Title: ZX Interface 1 New Layout SMD DIP

Size: A4	Date: 2026-10-28	**Rev: 2.0**
KiCad E.D.A. 10.0.6		Id: 2/3

Sheet: /Serial IO/
File: Serial_IO.kicad_sch

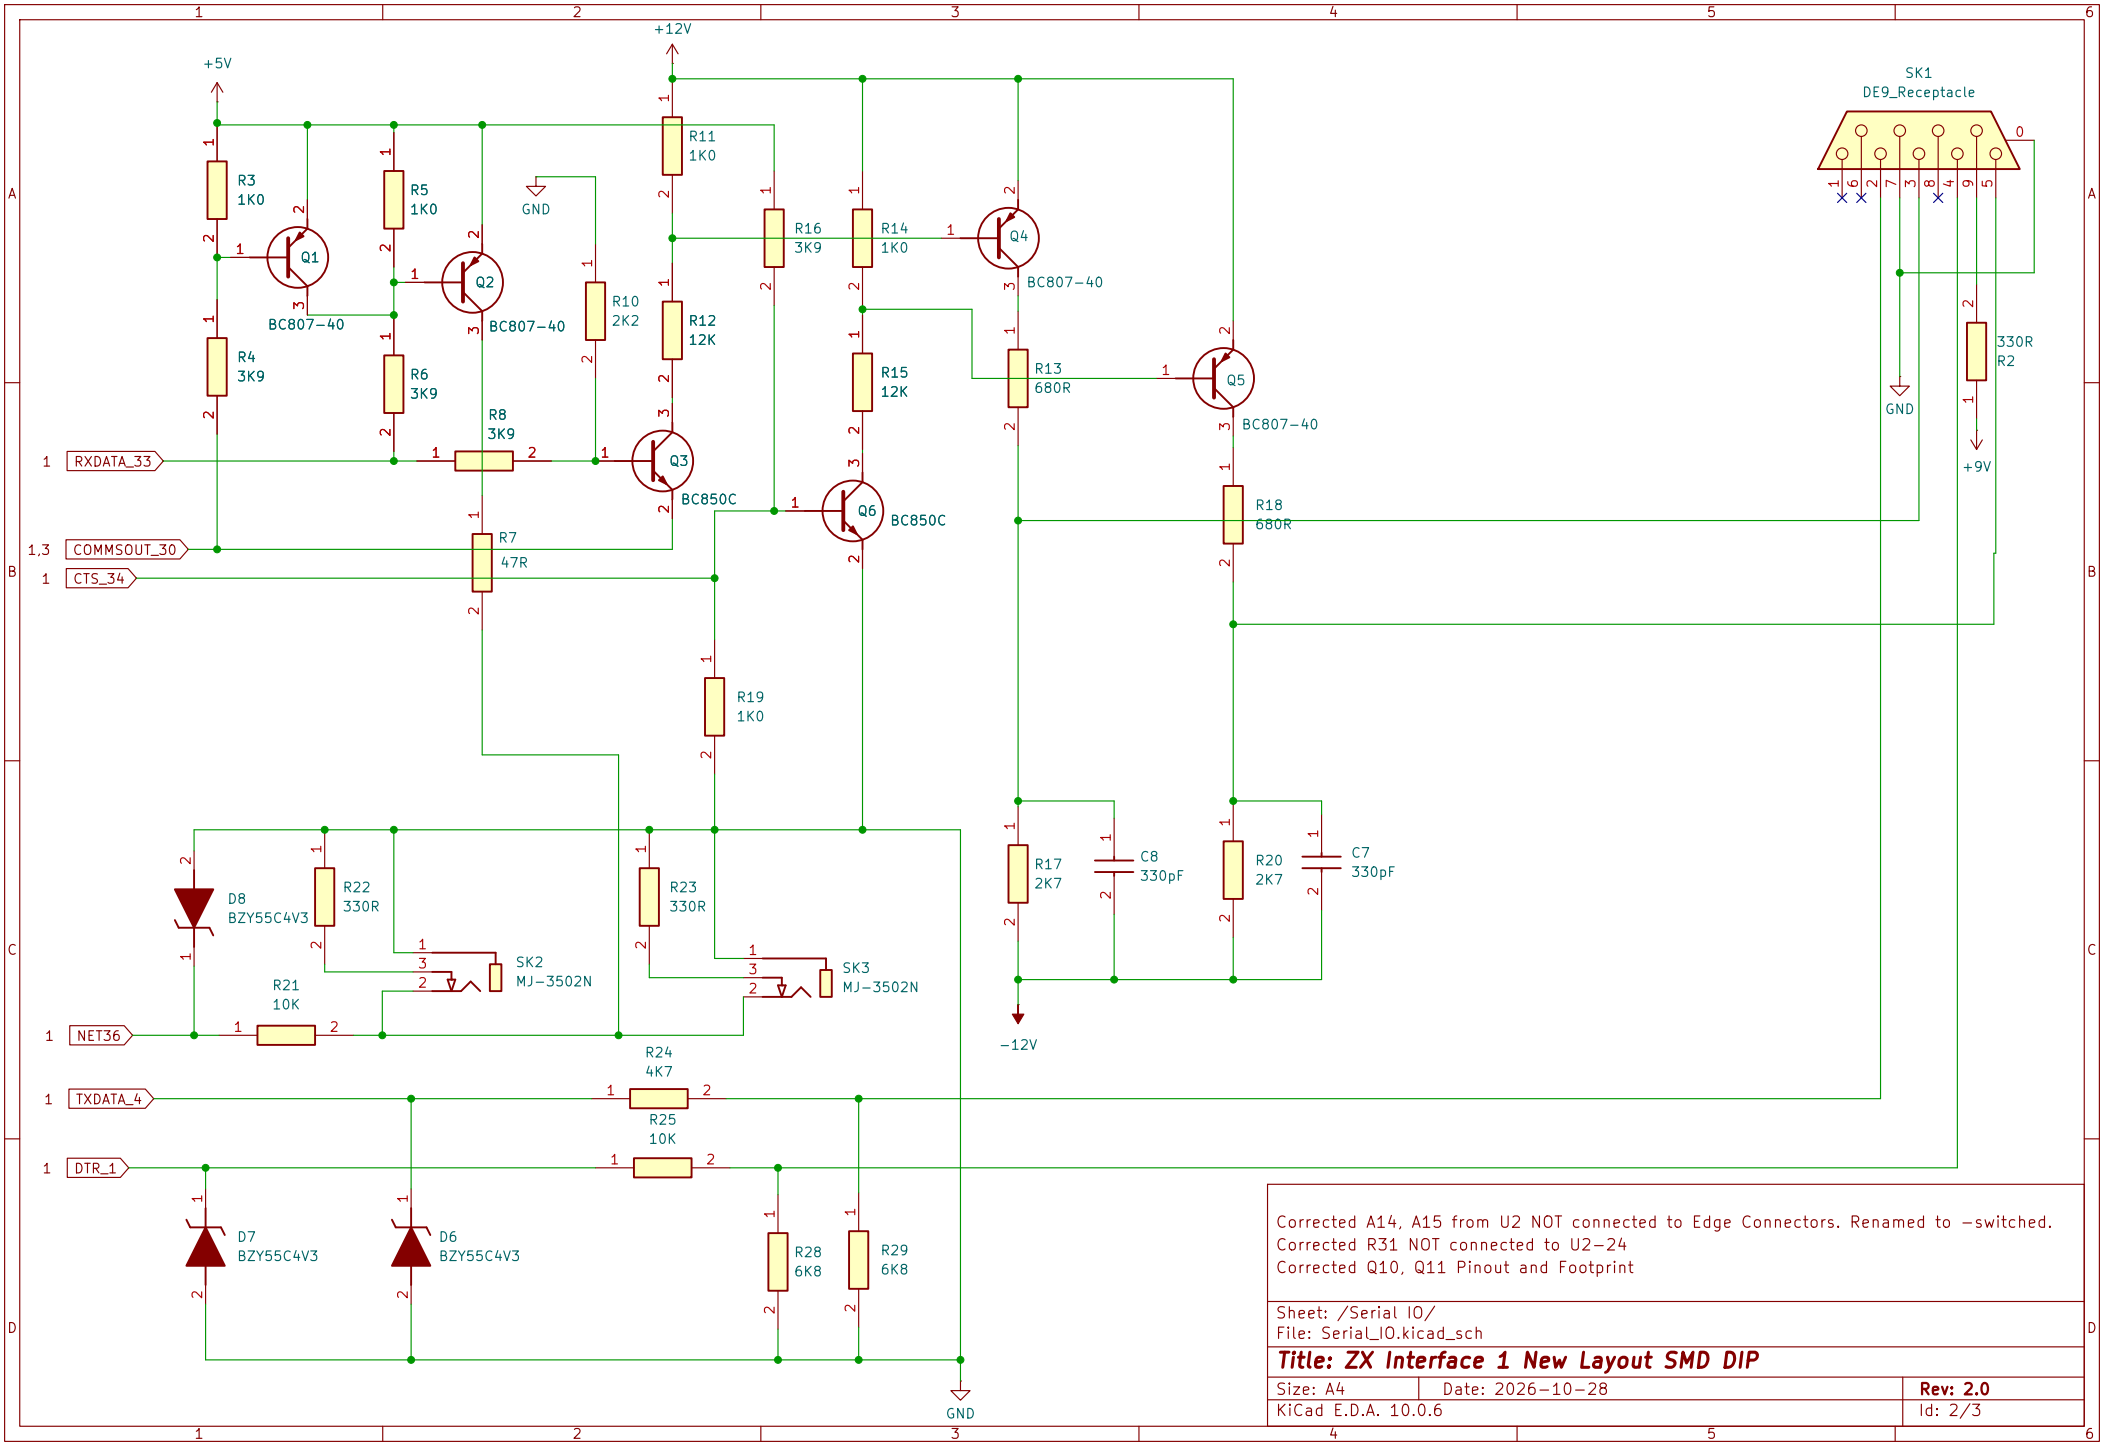
Corrected A14, A15 from U2 NOT connected to Edge Connectors. Renamed to -switched.
Corrected R31 NOT connected to U2-24
Corrected Q10, Q11 Pinout and Footprint

Sheet: /Microdrive IO/
File: Microdrive_IO.kicad_sch

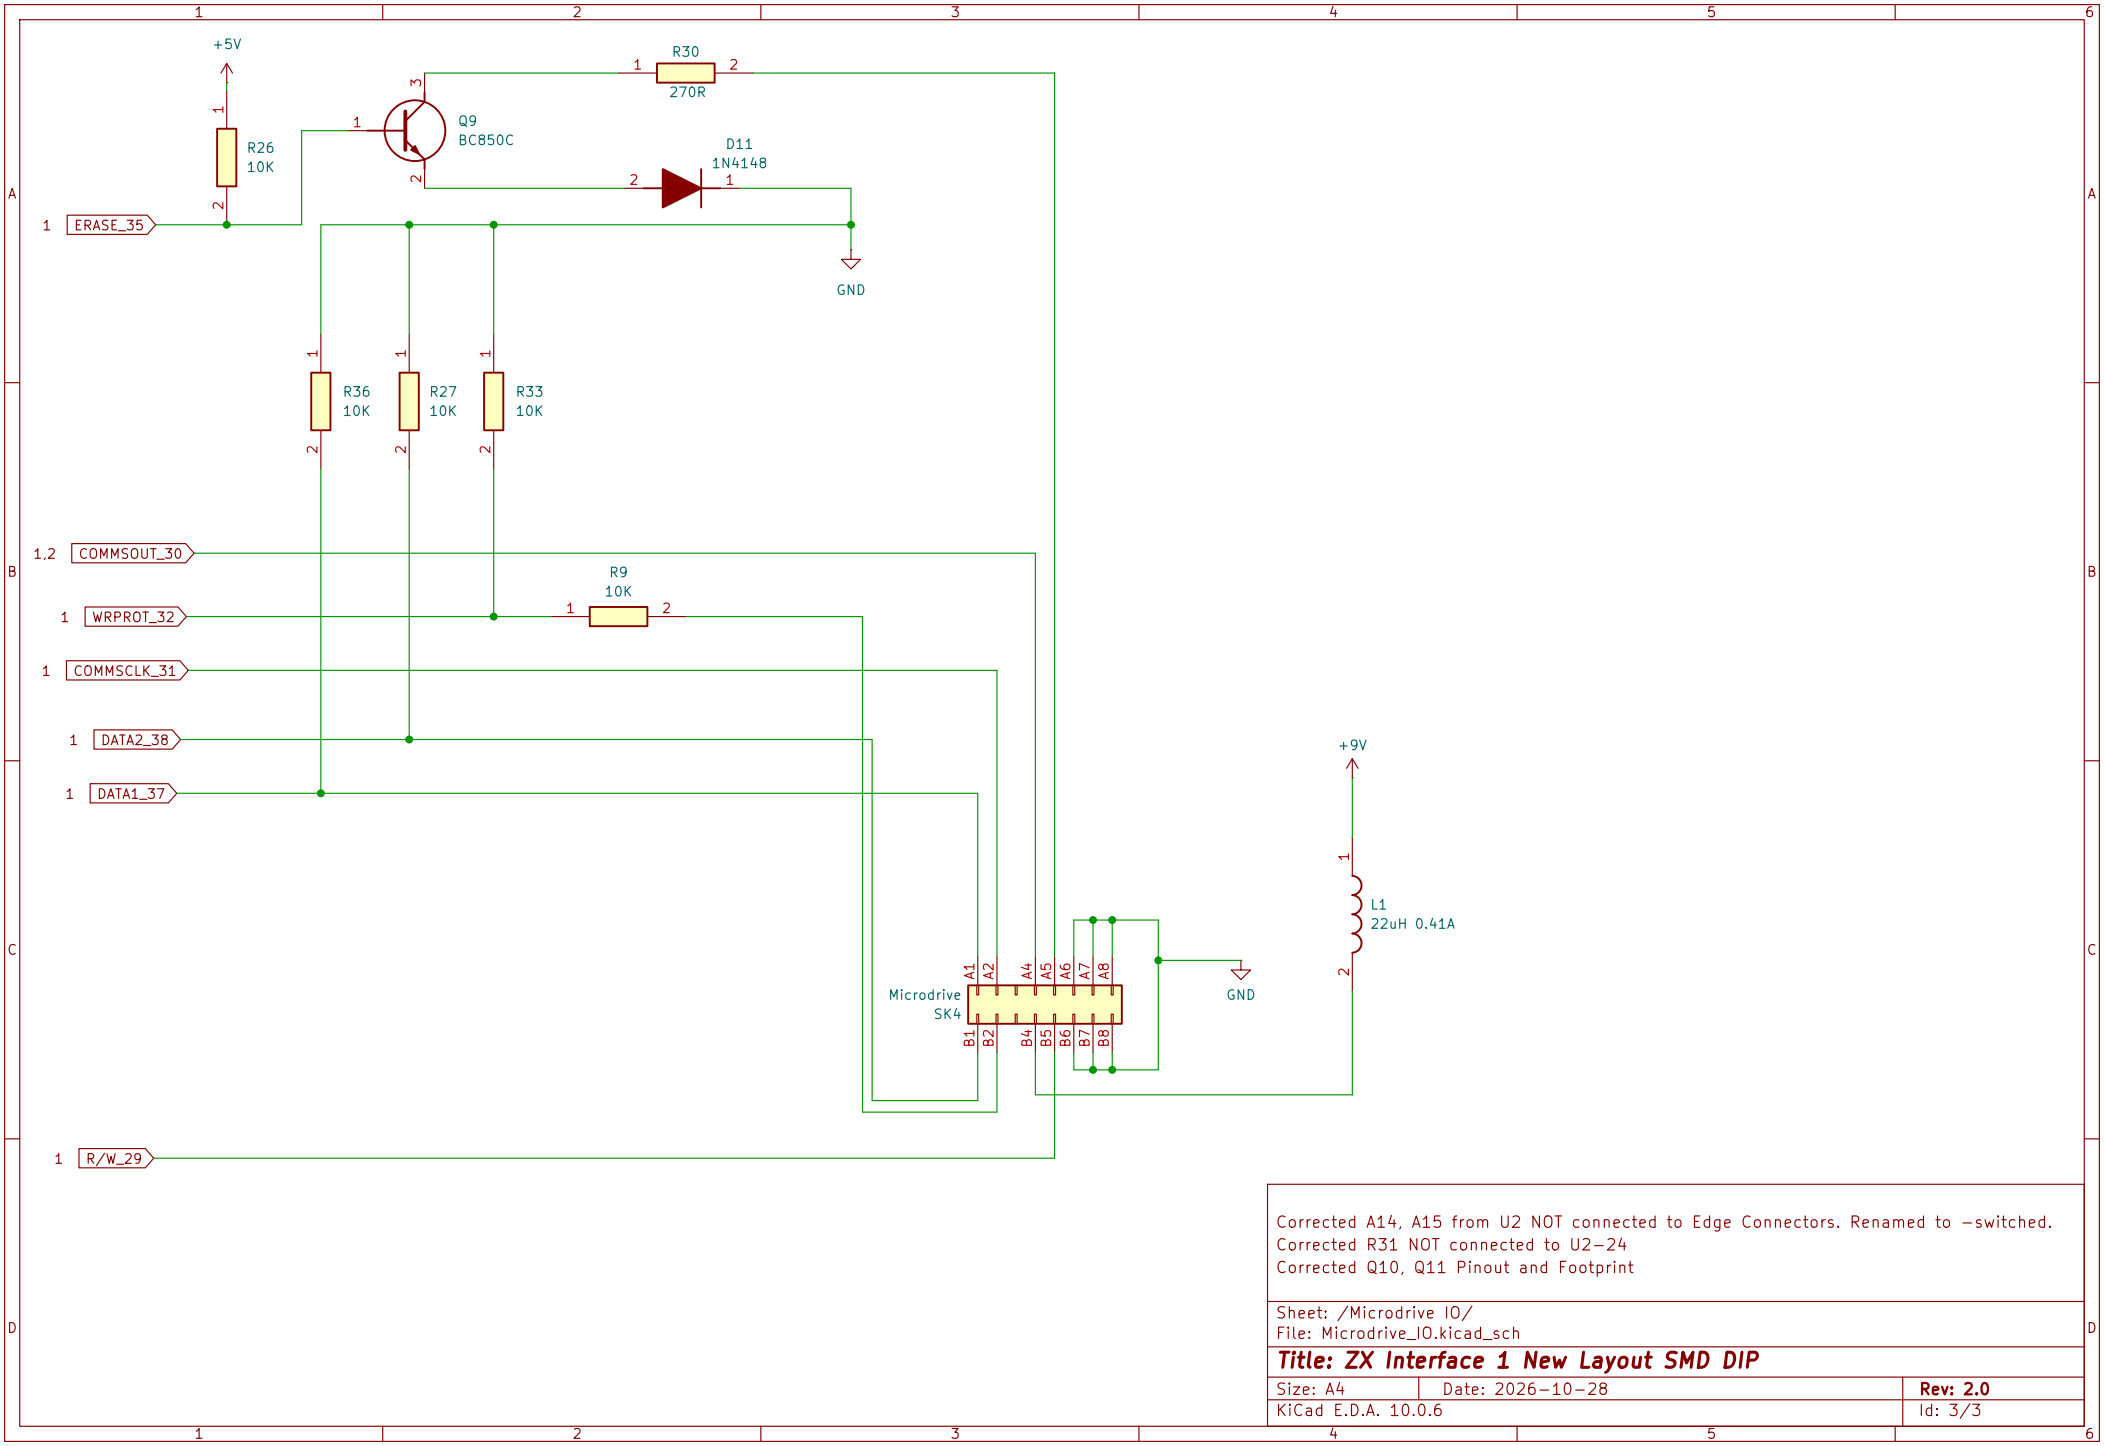
Corrected A14, A15 from U2 NOT connected to Edge Connectors. Renamed to −switched.
Corrected R31 NOT connected to U2−24
Corrected Q10, Q11 Pinout and Footprint
